Engine Information: R-1340-AN-1  
Engine Serial Number 13580  
Covington Work Order 11883  
Date of Disassembly 5/6/13

This report is in response to Par Erixon request after conferring with Covington Aircraft Engines since early 2011 with regards to concerns about the engines recent overhaul. Visible signs of corrosion, oil consumption, and leaks were areas of initial concern. The engine was shipped to Covington and disassembled in the presence of an external expert witness.

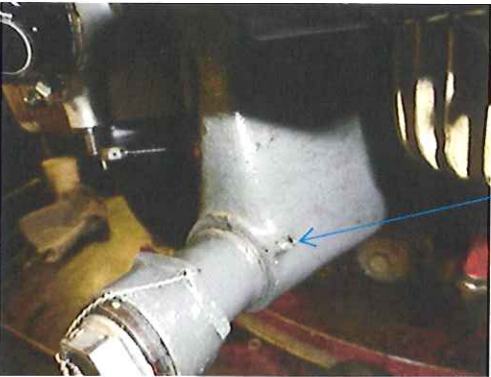
Incorrect Hardware (clamps) was used in all cylinder-to-cylinder drain lines. The clamps used appear to be general purpose hardware. The correct Part Number is 395296 as listed IPC Manual.

100% Incorrect cylinder base nuts were installed. The correct part number is 110514 as listed IPC Manual.

Incorrect hardware clamps used. The correct part number is 395297

Note : Incorrect engine hardware used. The clamp and drain nipple used are general hardware. The correct part number for drain nipple is P/N 14669 & the clamp part number is P/N 395296.

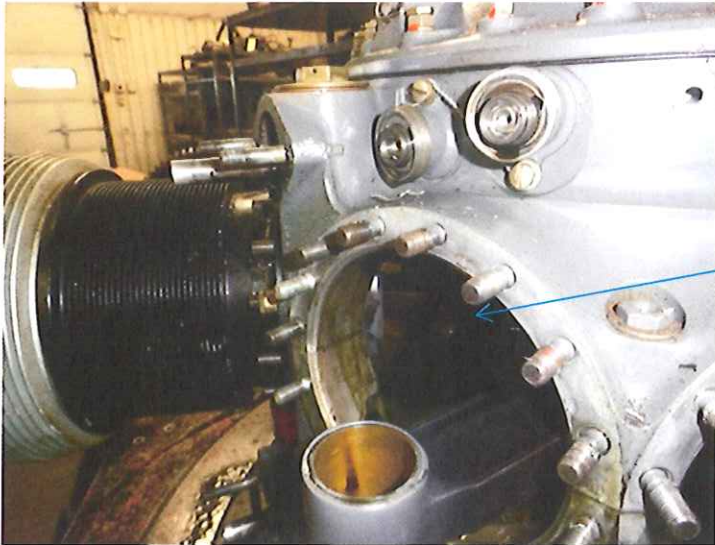
Note the oil sump "neck" is not safety wired & the safety wire lug is pulled through. No safety wire was evident at disassembly.

Note that the engine lifting eyes are located on the top of the case which is the configuration for helicopter installations. Fixed wing applications require the lifting eyes located behind the cylinders.

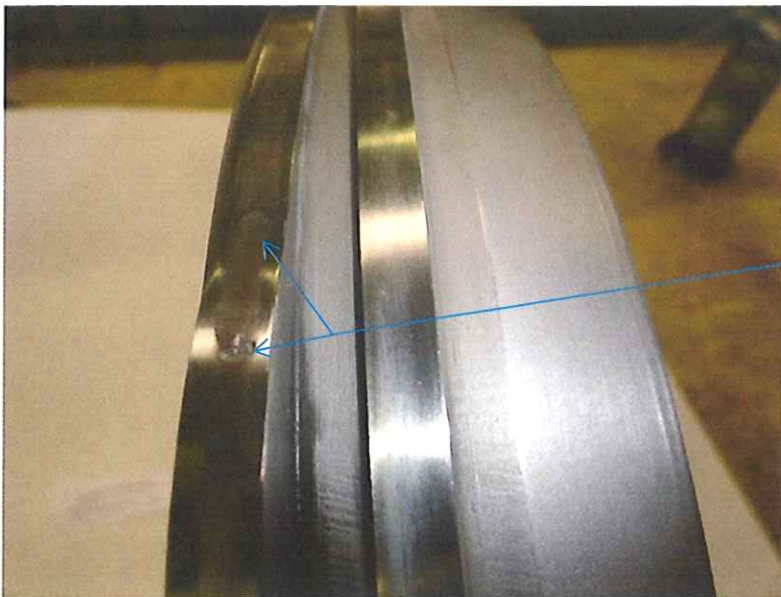
The master rod (P/N 39737) is located in the No. 1 cylinder location. This is direct contrast to the overhaul manual which states "Be certain that masterrod fits in the opening for the No. 5 cylinder"

As shown, Link Rod (P/N 3469) located in the No. 5 cylinder position.

Lockwire securing lock bars require no less than .051 per the overhaul manual. The lockwire used on this assembly is .041.

It is widely accepted to accomplish SB1546 which allows for the corners of the master rod bearing lip to be dressed. This aids in reducing crack causing stress points in the bearing. Covington Aircraft observes this S.B. And will not release a repair or overhaul that has not had this S.B. accomplished.

Corrosion found on the rod as pictured. It appears there were attempts to clean the corrosion, however by Covington tolerance & our understanding of the functionality of this part, this part is rejected and not repairable. See inspection letter attached.

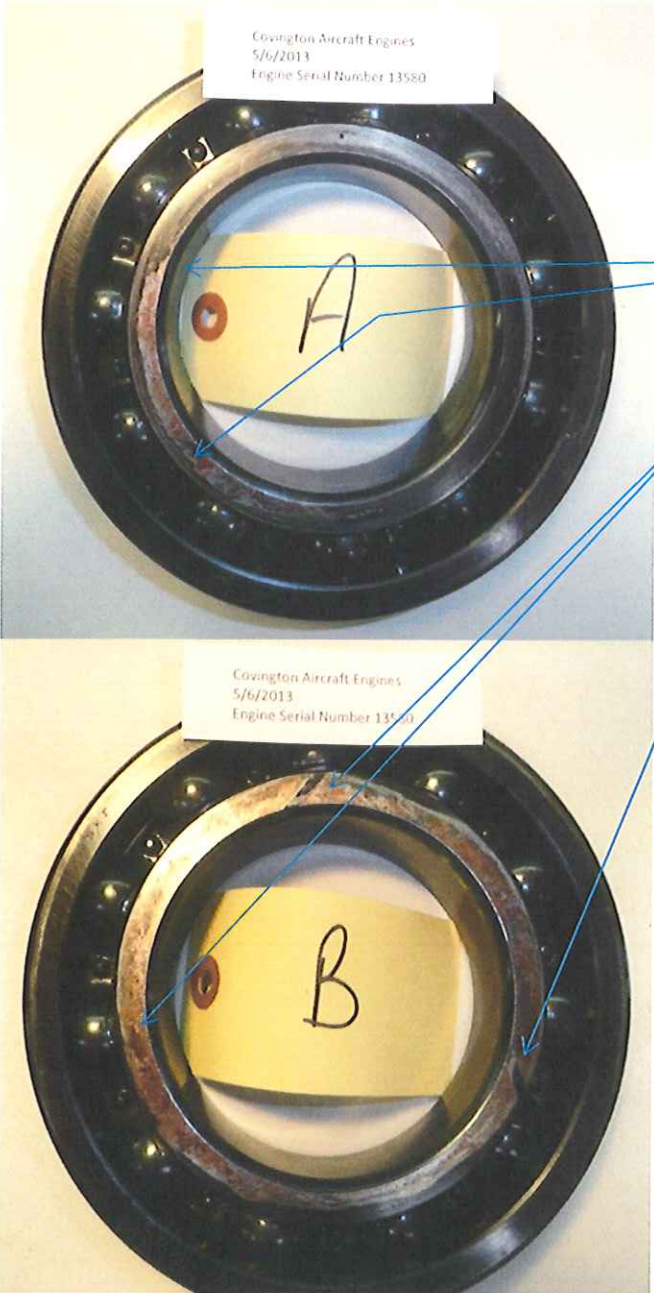
Closer view of the corrosion in question.

As shown deep pitting and tracking are evident on the Cam (Serial Number 118418). The cam is operationally failing and unable to be repaired and put back into service.

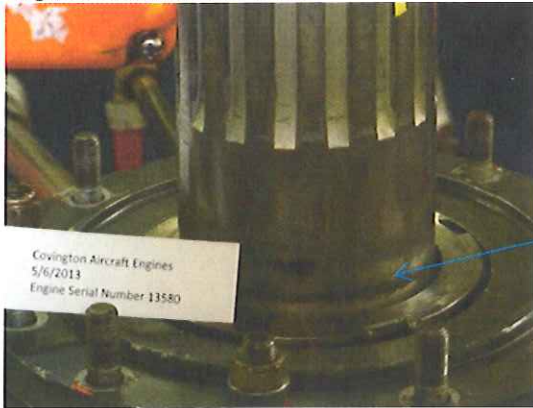
Starter Gear (P/N 3278) as removed. No rust or corrosion was present however deep surface pitting is present on the gears shaft.

Trust bearing (P/N 326197) show witness marks from the engines slinger ring (P/N 303732). This does not reject this bearing however it would appear that this bearing has been installed more than one time.

Front Main Bearing (P/N 288941) as removed. This bearing is in serviceable condition. Note the witness marks on the inner race of the bearing. This is caused by an access port on the crankshaft. There is only one port on the shaft that lines up with this bearing race. This bearing would appear to have been installed more than one time.

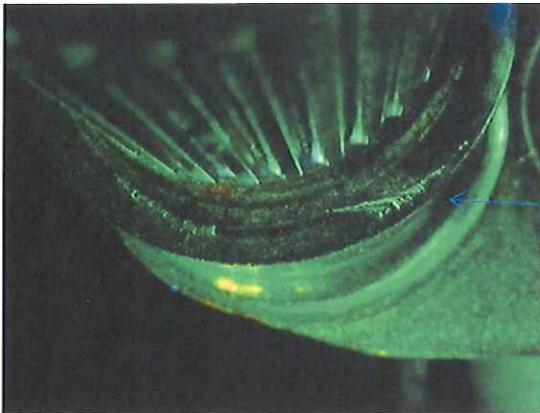
The rear main bearing as photographed (P/N288941) is in serviceable condition. Please note that the part numbers from the inner race does not match the part number of the outer race and retaining ring. Although this is acceptable, it would indicate that the bearing was not new when installed.

Corrosion and Pitting are evident on the crankshaft forward of the thrust nut (behind the propeller splines). The crankshaft is repairable by hard chroming this journal in accordance with Pratt & Whitney Plating Manual 238649.

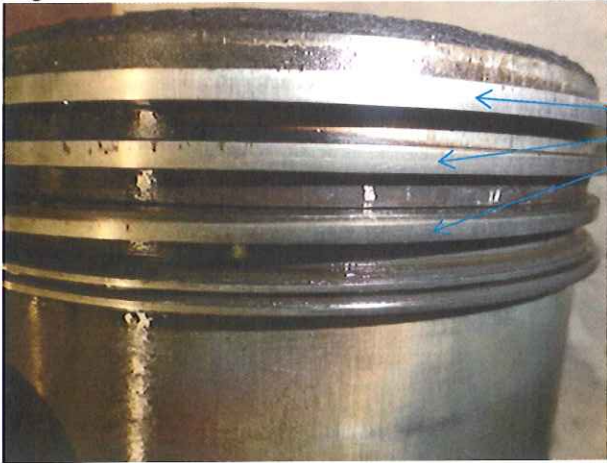
Note: At 67 since major overhaul, it appears that no plating work was done to address the corrosion issues.

Crankshaft (S/N 20A6670) as photographed under a black-light (magnetic particle inspection). The crankshaft does show small crack indications that we feel can be addresses as per Pratt and Whitney repair instructions. We will need to remove the crack and measure to verify the serviceability of the part.

Piston Pin (P/N 234220) as removed from position (cylinder / piston) #3. Comparable to the remaining eight piston pins. The pins do not exhibit any corrosion however are pitted. The pin size in as removed condition is within service limits, however once the pitting is removed the pin sizing will need to be inspected and verified.

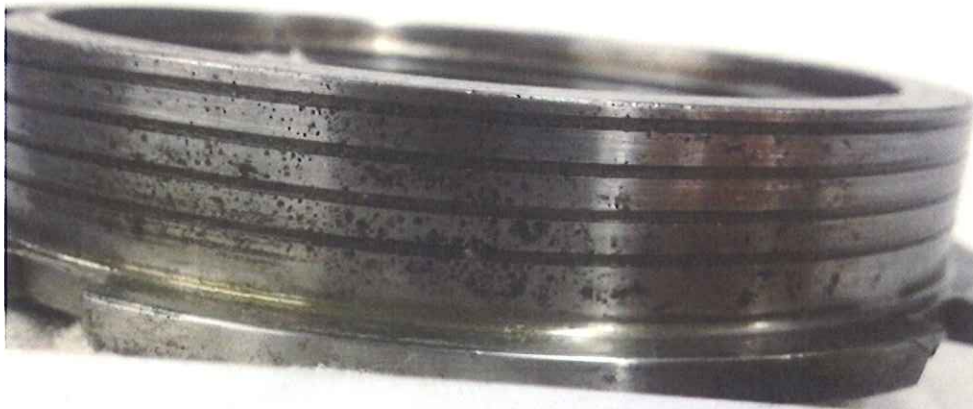
Piston as removed from cylinder #3.  
Comparable to the remaining eight pistons.  
The rings show excessive wear however  
side clearance / tolerance are within limits.

Photographed thrust nut  
(P/N 12719) as removed.  
No Rust or corrosion  
was found on the part,  
however there is  
significant pitting that  
condemns the part.

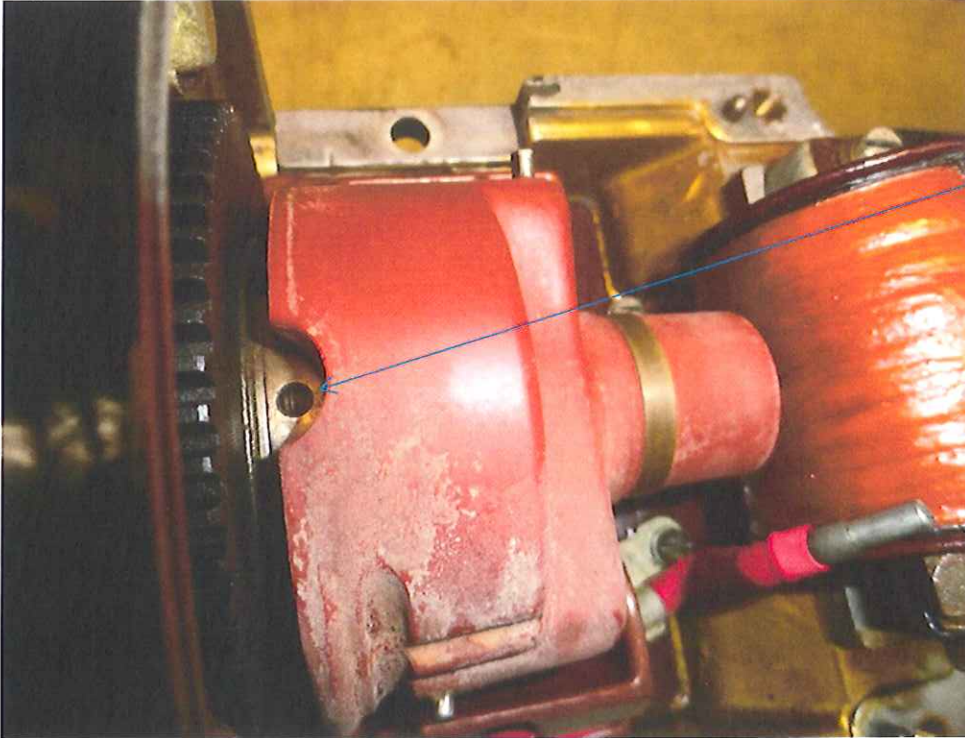
Photographed Thrust Plate (P/N 37970) as removed. Heavy scoring / gouging are present at the I.D. of the plate that will condemn the part. There is not found an operational cause for the condition of the part as the thrust nut shows no sign of corresponding damage.

Photographed are seals (P/N 24230) located in the engine oil pump. The leather seals appear to be well worn and are semi-recessed in the housing.

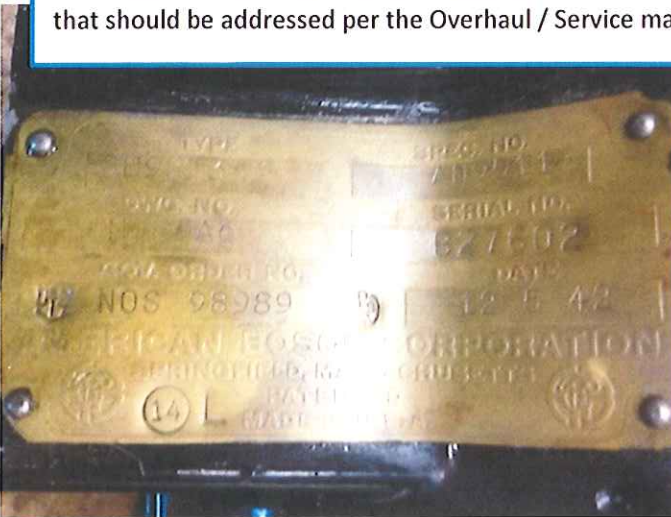
Note the following:  
The manual for the American Bosch (SB9RU3 / C3) magnetos require that the rotor fastening screws (P/N SC5294) be staked. Both fastening screws were un-staked as photographed.

Note that the hardware has not been plated or addressed, also the housings show chips and imperfections that should be addressed per the Overhaul / Service manual

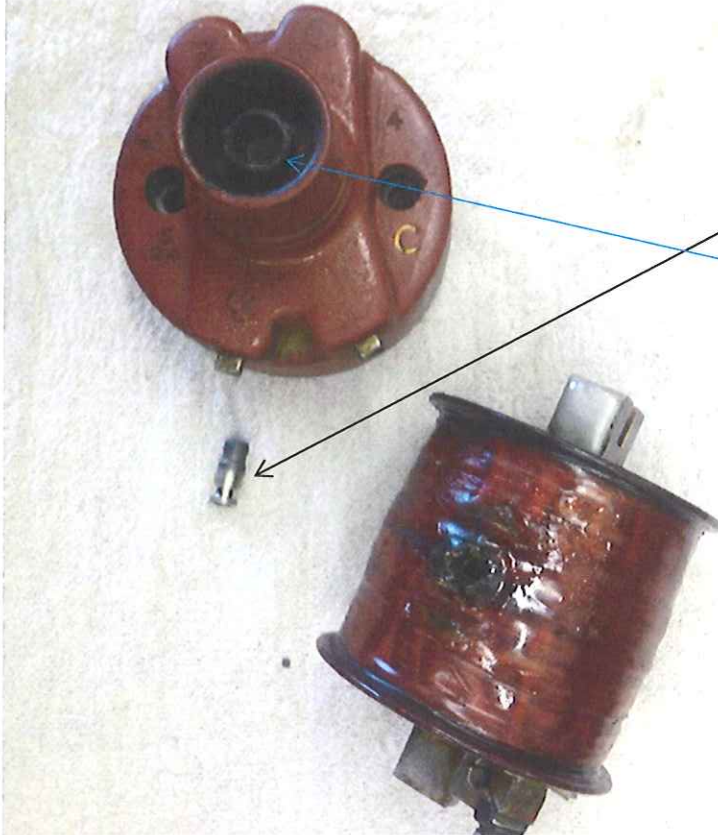
Cam (P/N CA5241) is pitted and rejected.

Gear (P/N GE52198) is pitted & has one gear tooth damaged. This part is rejected.

Rotor (P/N RT52137) & Coil (P/N CL5250) are rejected due to the coil terminal breaking loose from the coil. This terminal fits into the inner diameter of the rotor, because this terminal is loose it will (as the magneto is operating) damage the inner diameter of the rotor as photographed. It is possible for the magneto to keep operating with this failure, however most magnetos fail completely or exhibit high rpm drop when magneto checks are performed.

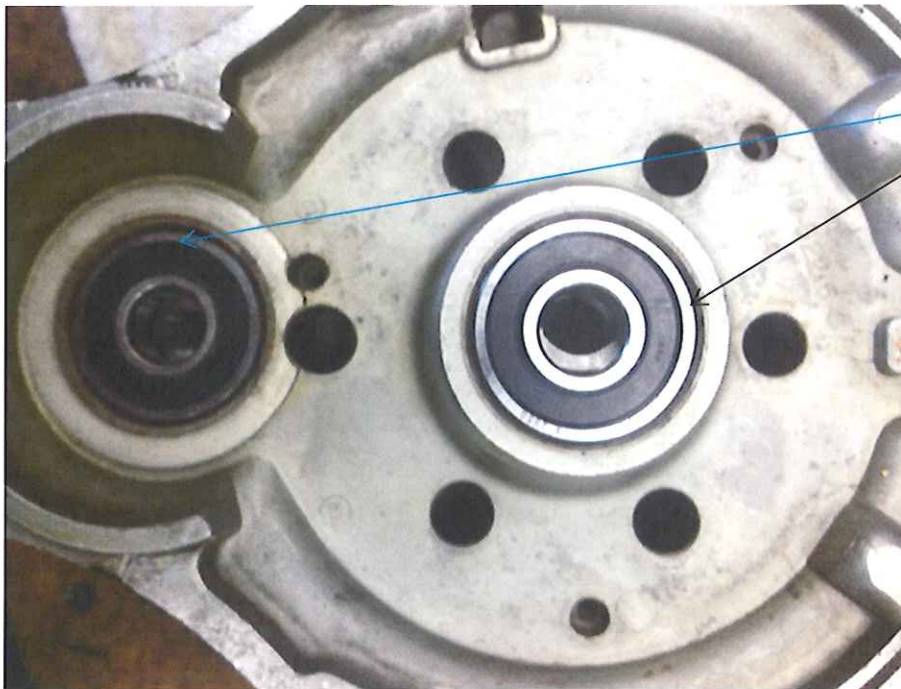
Incorrect bearings used. The manual calls for BB1019 & BB5210 slotted bearing. The bearings used appear to be SKF0201, which I cannot reference.

Also note that the sealer is nearly removed from the housing.

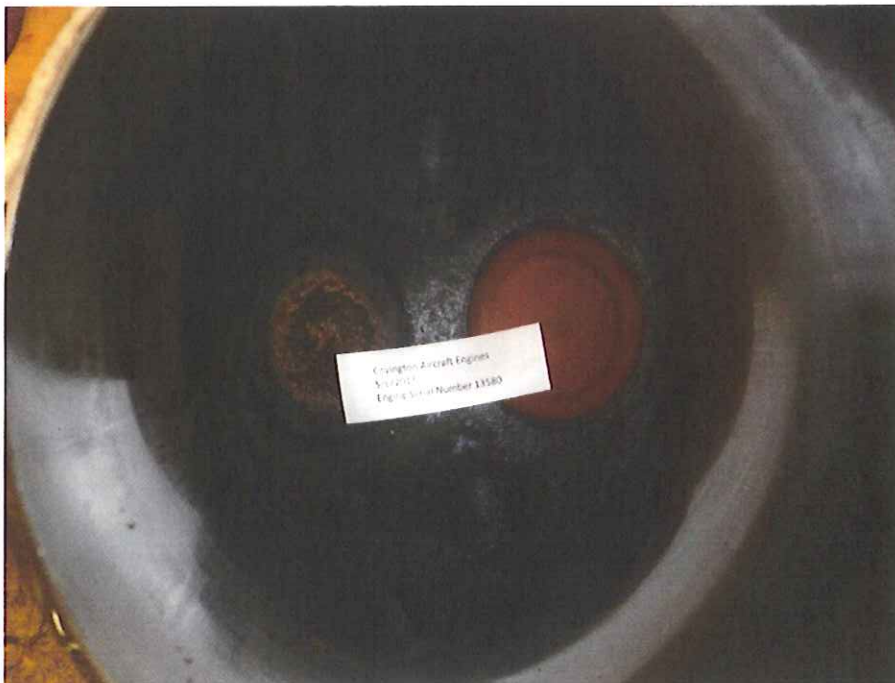
Note: The combustion chamber seems to have a high amount of combustion residue that would indicate that the engine did use (consume) more than average amounts of oil. This would be consistent with the marginal bore to piston sizing, apparent lack of honing, and excessively worn rings. To complete an inspection of the cylinders, valves, bearings & springs, full disassembly will be required.
